AGENDA
JANUARY 13, 2026

Application 25-25 15 Plum Tree LLC-Permit approval to construct a 3 story apartment building & 9 attached townhouses, a retaining wall, subsurface stormwater detention system, level spreader, sidewalks and storm drainage within a regulated area at 5 & 15 Plumtree Lane.

MILL RIVER PARK 5 & 15 PLUMTREE LANE TRUMBULL & EASTON, CONNECTICUT

**EROSION &
SEDIMENT
CONTROL PLAN**

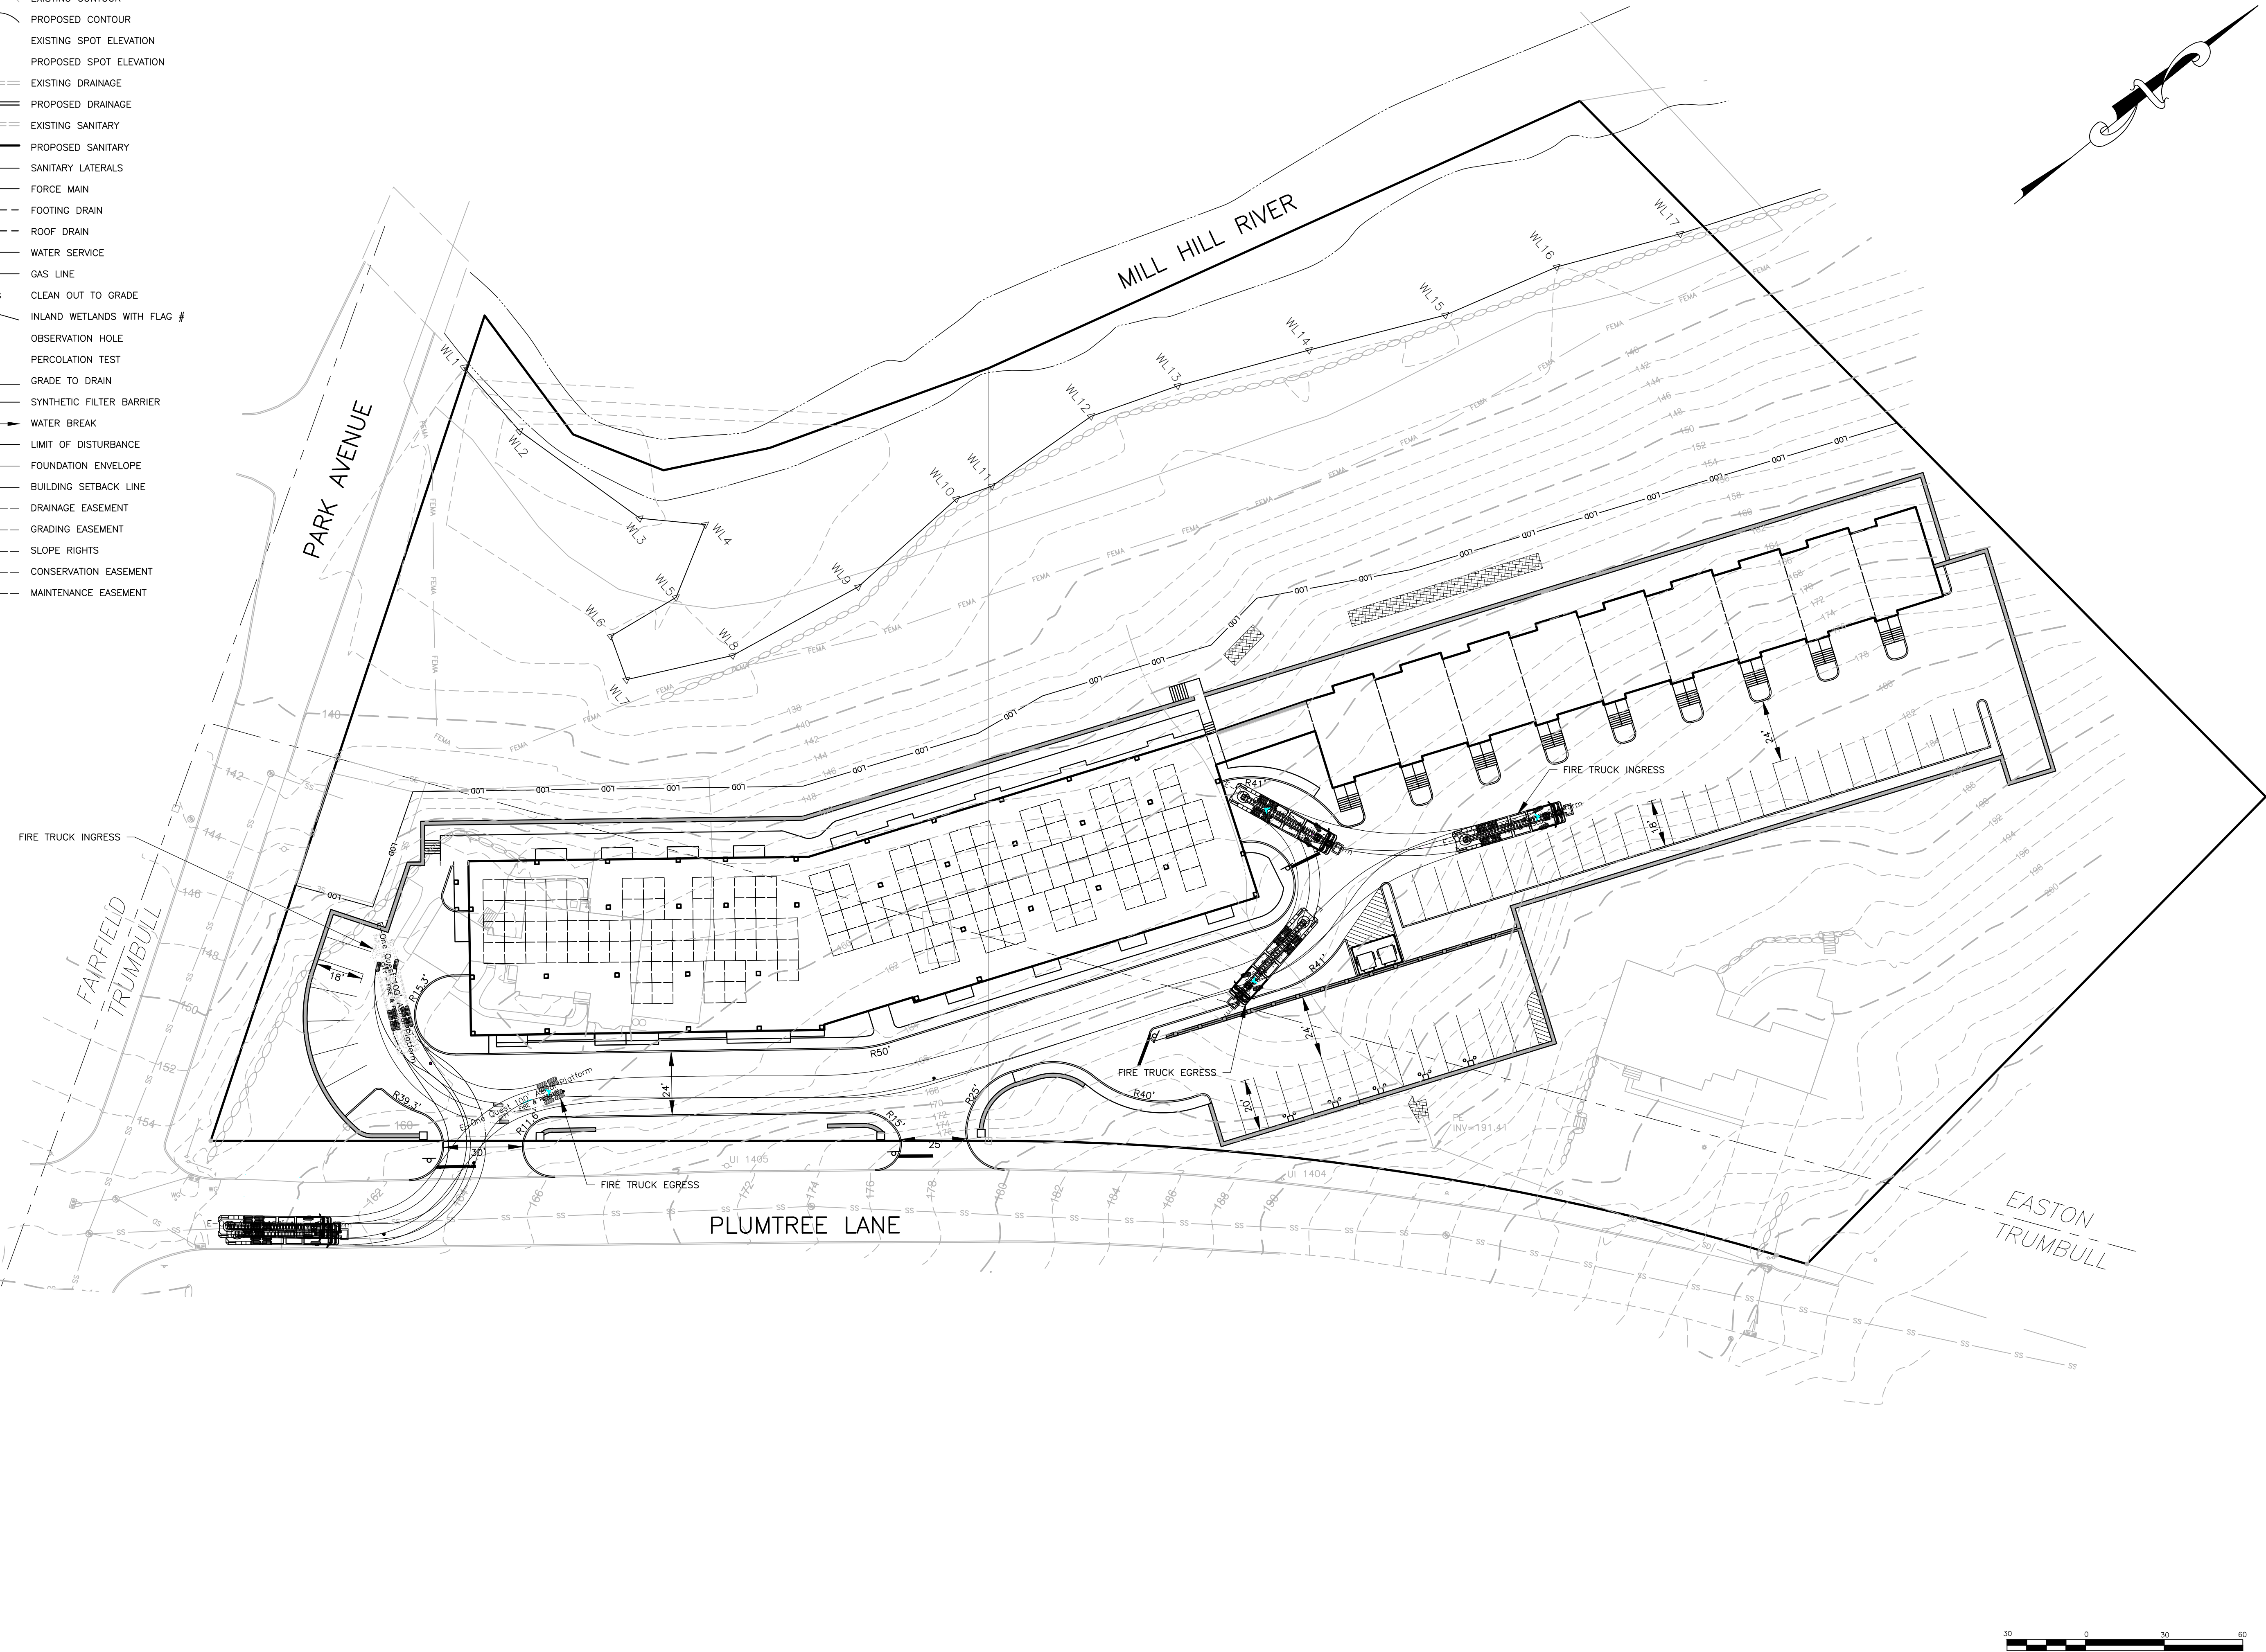
- 6) The Erosion and Sediment Control Plan (Sheet 2.3) shows a double row of silt fencing along the limit of disturbance. Due to the disturbance of the upgradient steep slope and the large area of overall disturbance on the property, we recommend the placement of hay bales in between the two rows of fencing. The hay bales will provide additional stability to the upgradient fencing as well as additional filtration capability to the controls.

Sheet 2.3:

Sheet 2.3 – Erosion & Sediment Control Plan:
